MEMORANDUM

CITY/BOROUGH OF JUNEAU
155 South Seward Street, Juneau, Alaska 99801

FILE NO's: VAR2013 0024 & VAR2013 0025

PROPOSALS: A variance to reduce both side yard setbacks from 10 to 5 feet, and a second variance to increase the maximum allowed height from 35 feet to 50 feet for a new 15-unit condominium in Auke Bay.

Figure 1: Elevation drawing of proposed parking deck and condominium building under one roof. Flood hazard line of 26 feet is indicated at its vertical axis by the dotted line. The front property line is labeled 'P/L' in the lower left hand corner.

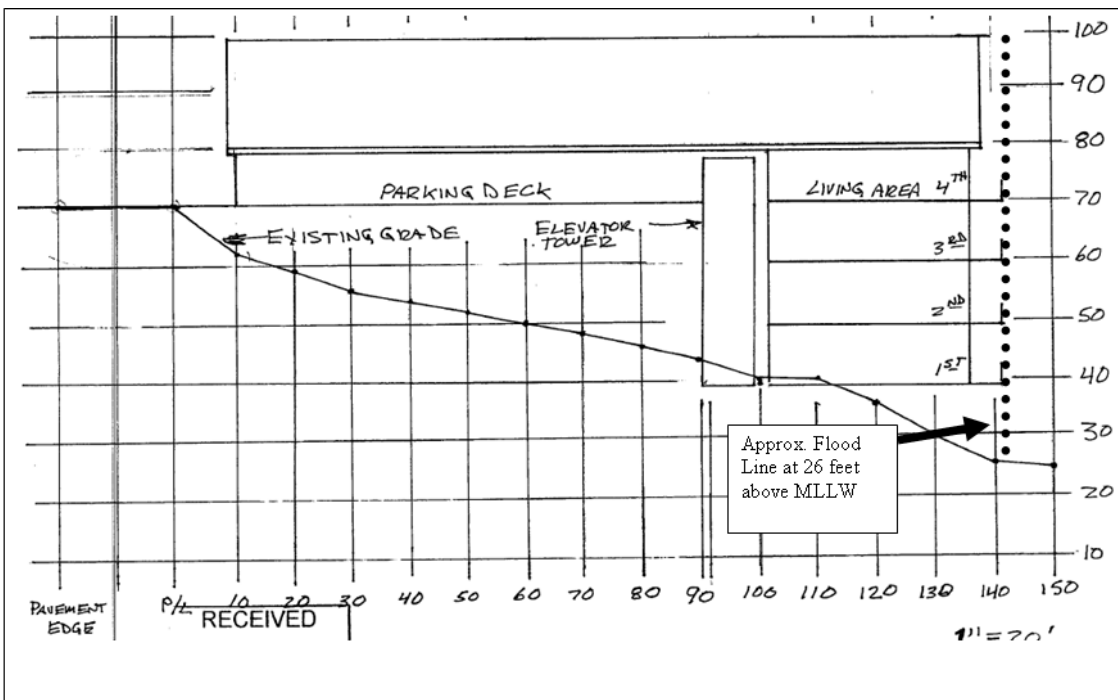
A portion of the property is affected by a Velocity (V), high-risk flood zone with a base flood elevation of 26 feet above mean lower low water mark¹. Any part of the building below this elevation is susceptible to flood damage during a 100-year storm event. Also, condominium owners will be required to pay flood insurance in addition to regular homeowners' insurance. The applicant designed the building, including its supporting piers, to be uphill and outside of the flood elevation line at 26.5 feet. See Figure 1. This forced the project uphill towards Glacier Highway. On the opposite end of the property, the 10-foot front yard setback acts to push the project downhill. Reaching the maximum building potential in this area results in the building and parking deck expanding horizontally (North-South direction) five feet into both 10-foot side yard setbacks. See Attachment B.

feet is added and the height measurement starts at 36.5 feet. Going up 35 feet to the maximum allowed height will reach 71.5 feet. The remaining distance to the midpoint of the roof is 18.5 feet. This amount is covered by the height variance.

SITE PLAN

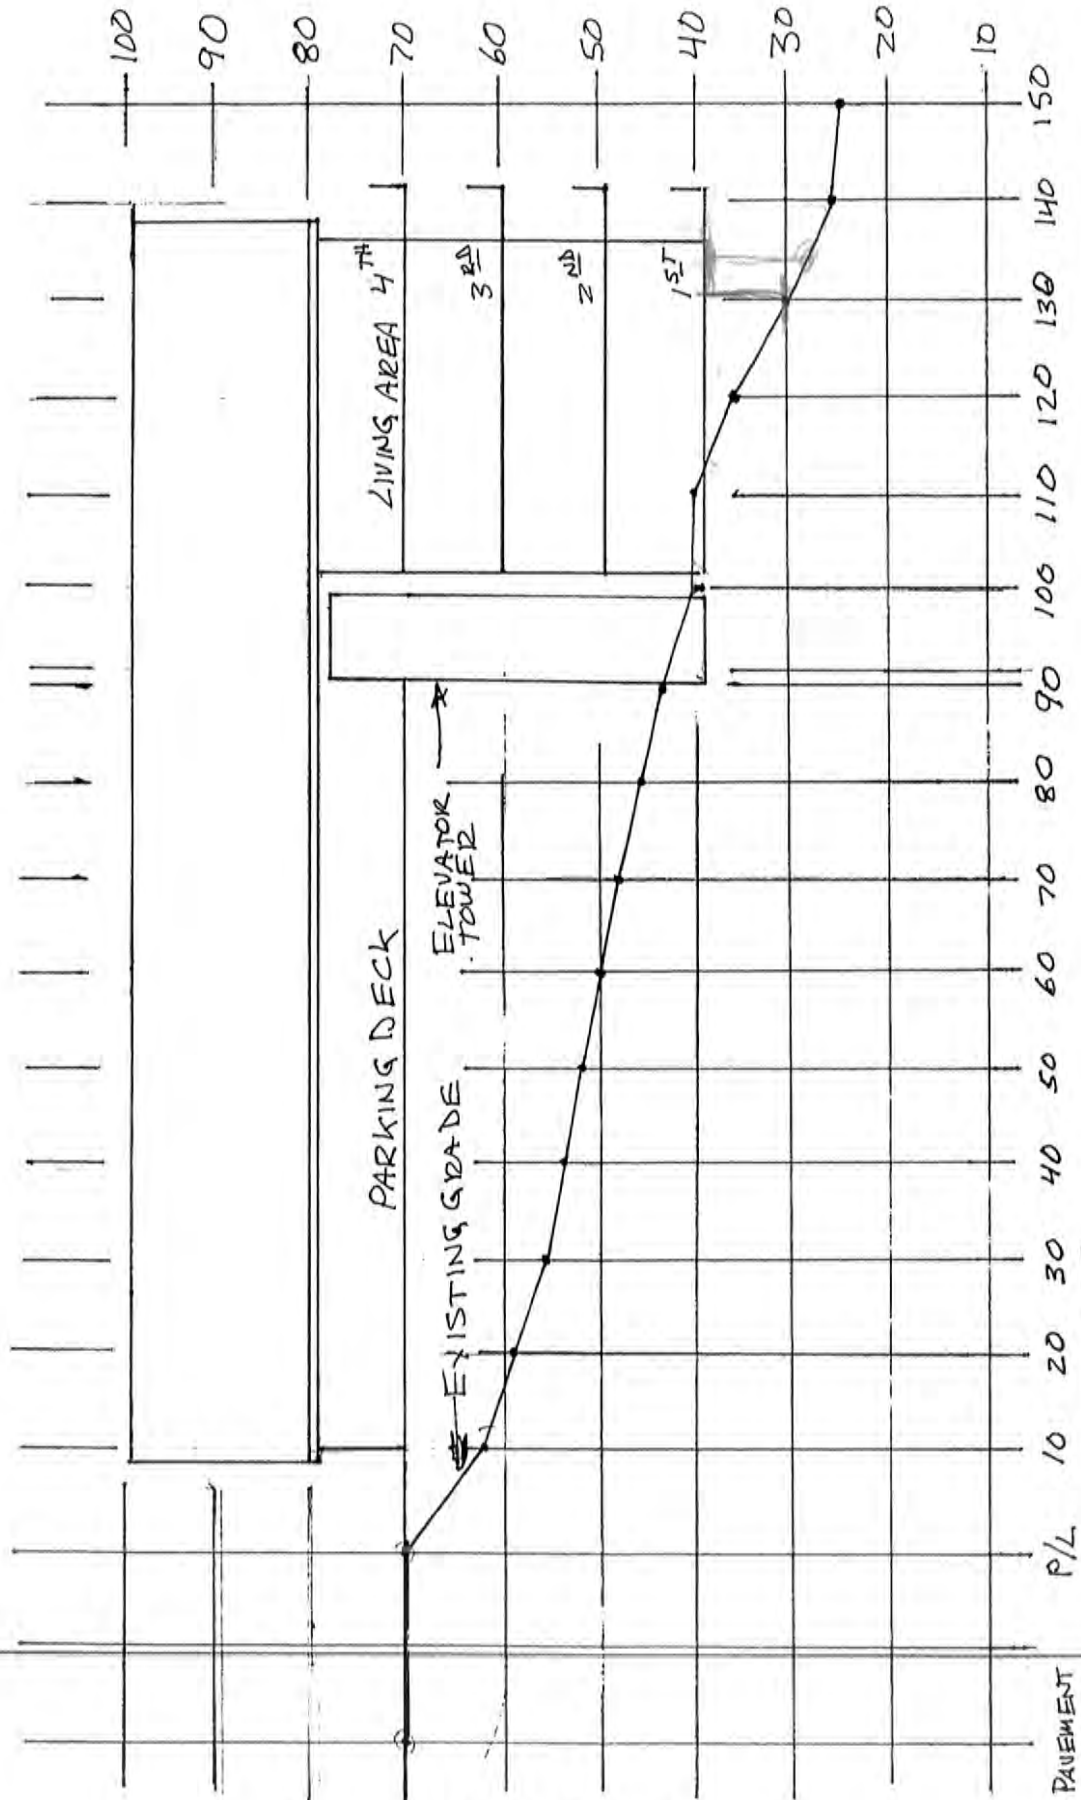
The roof eaves are shown closer than five feet from the both side lot lines. Although the Land Use Code allows eaves to encroach four inches per foot of yard setback, the overall encroachment of five feet exceeds the eave encroachment allowance. Therefore, the eaves are considered part of the variance. As measured on the attached plans, each roof eave is approximately 1.5 feet long. If the variance is approved, staff recommends as a condition of approval that a surveyor ensures the building and parking deck are no closer than five feet to both property lines, and that the roof eaves are no closer than 3.5 feet from those same lot lines.

Reducing both side yard setbacks from 10 to five feet for the condominium building and parking deck will have no impact to the adjacent apartment building to the north and little impact to the homes across Glacier Highway due to the steep slope. Drainage will continue downhill towards the tidelands as it currently does but concentrated along the side lot lines and behind the building.

- 1) Prior to the issuance of a Building permit, the applicant shall submit a site plan, and if needed, a narrative, showing/ describing how the snow will be managed on site. If snow will be partially managed on adjacent property, the applicant shall submit a recorded easement addressing snow management.
- 2) Prior to the issuance of a Building permit, the applicant shall submit documentation that will ensure the foundation of the parking deck and building will not be eroded by water run-off along both side property lines.
- 3) For the Building permitting process, a surveyor shall verify all yard setbacks of the Foundation Verification Setback Form.
- 4) Prior to Final Certificate of Occupancy, the applicant shall submit an as-built survey showing the parking deck, building and roof eaves all complying with yard setbacks.

SITE ELEVATION PLAN

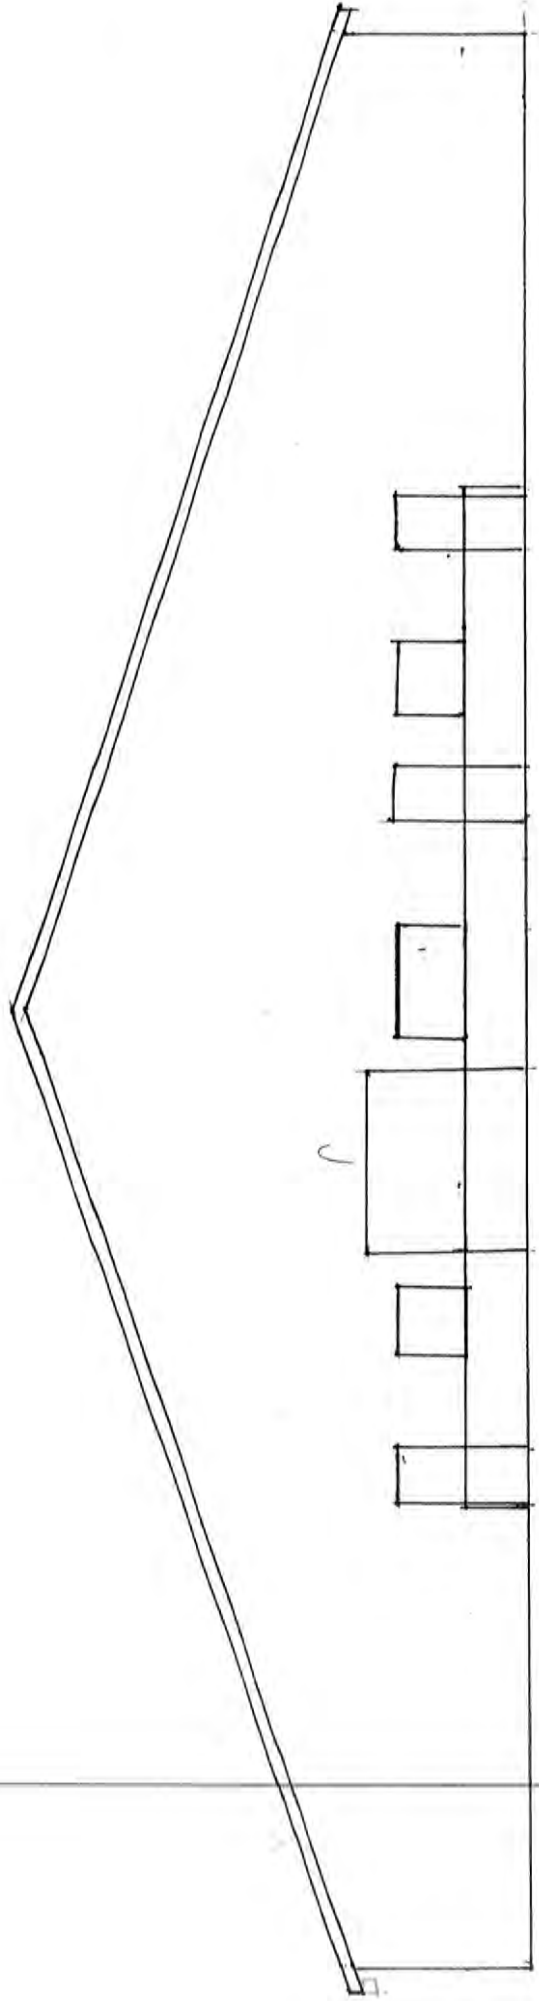
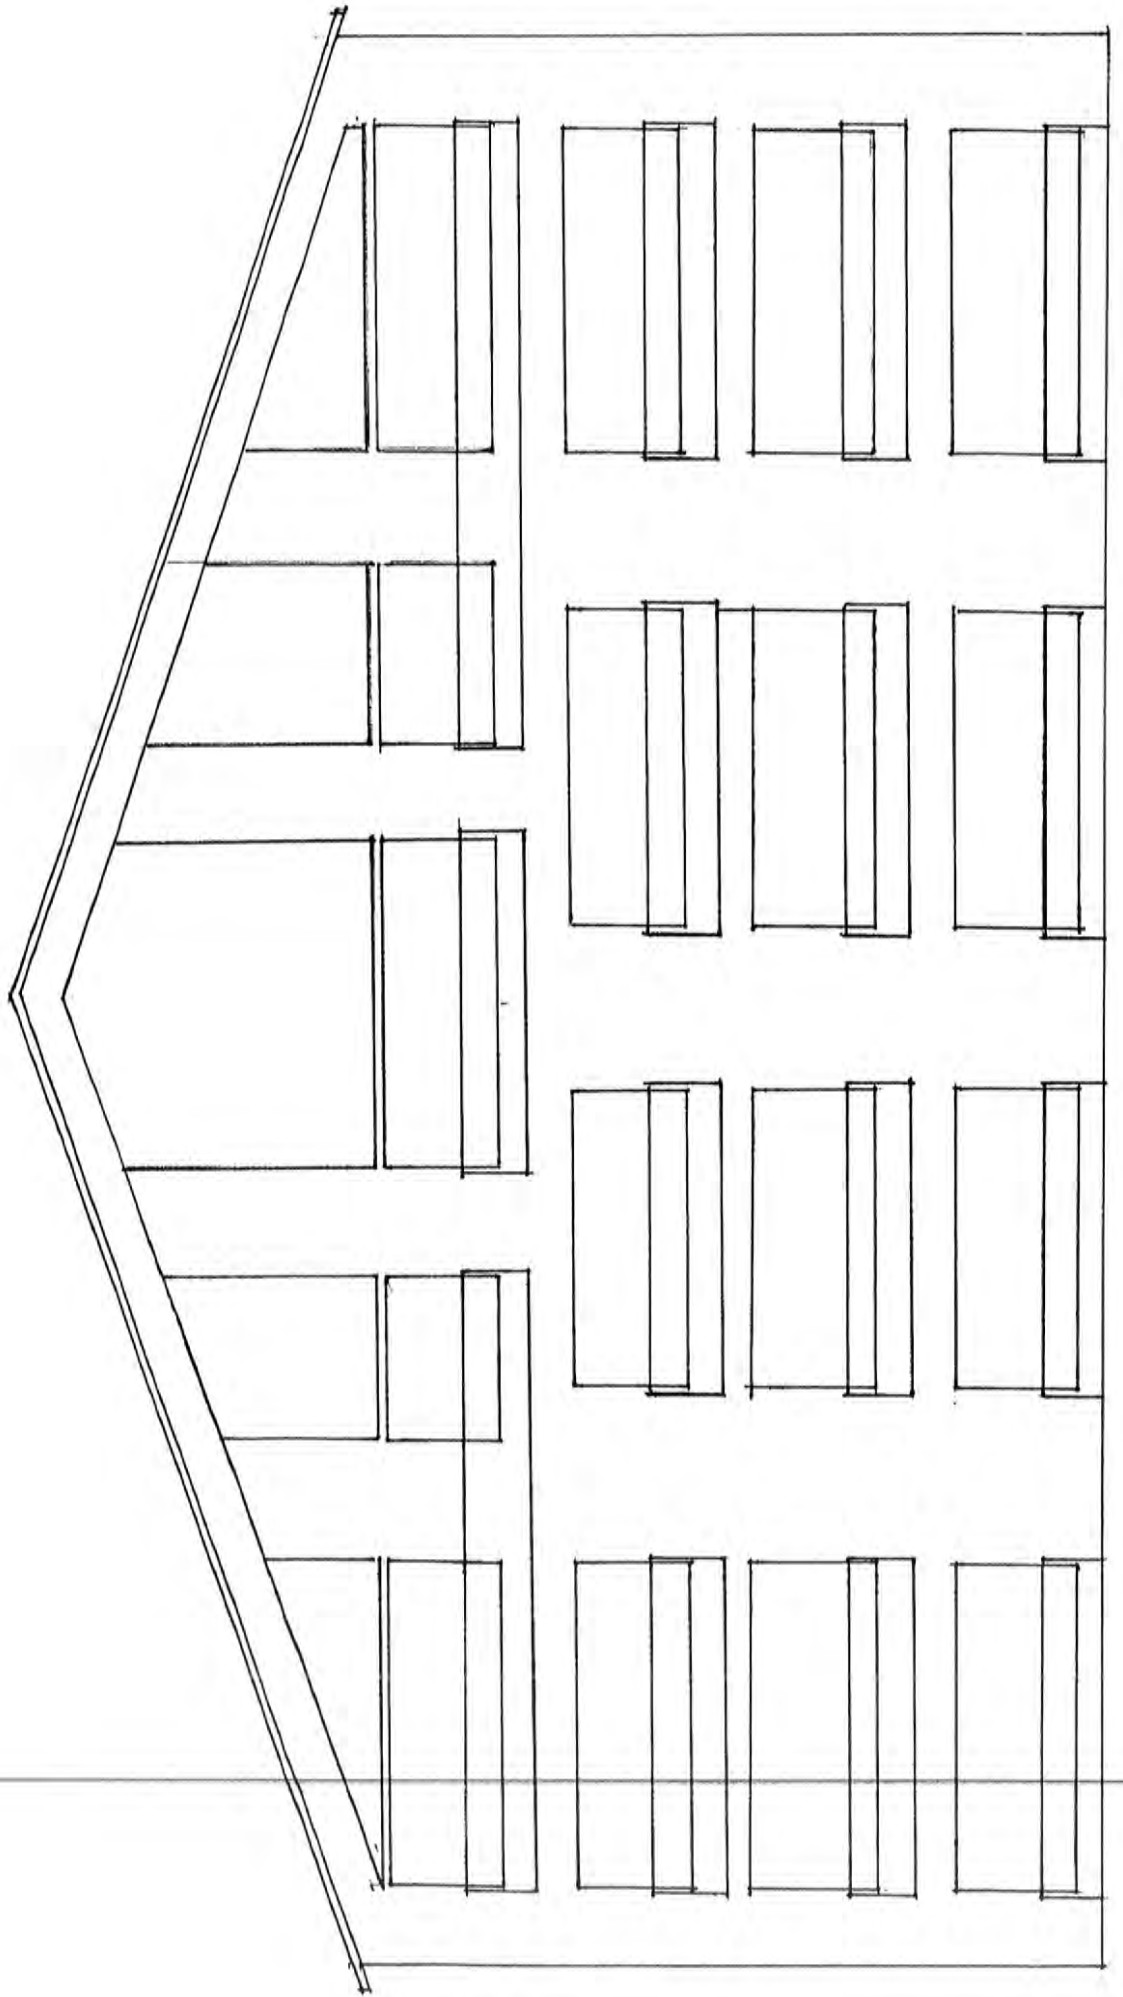
area that has resulted from the flood zone and steep topography. The reduced buildable area pushes the applicant's development horizontally as well as vertically. Elevation drawings are provided under Attachment C, respectively. Due to the steep topography, only the top floor will be at the same grade as Glacier Highway; all other floors will be below the height of the parking deck. Therefore, the building will appear as a single-story structure from the road. This is a common design outcome of buildings along coastlines.

As stated earlier, the overall height of the four-story condominium building will exceed the maximum height of district but will appear as a single-story building from the roadside. Views from residences across the road will not be minimized and may increase with the removal of the existing tall trees. The additional height will not affect public safety or welfare.
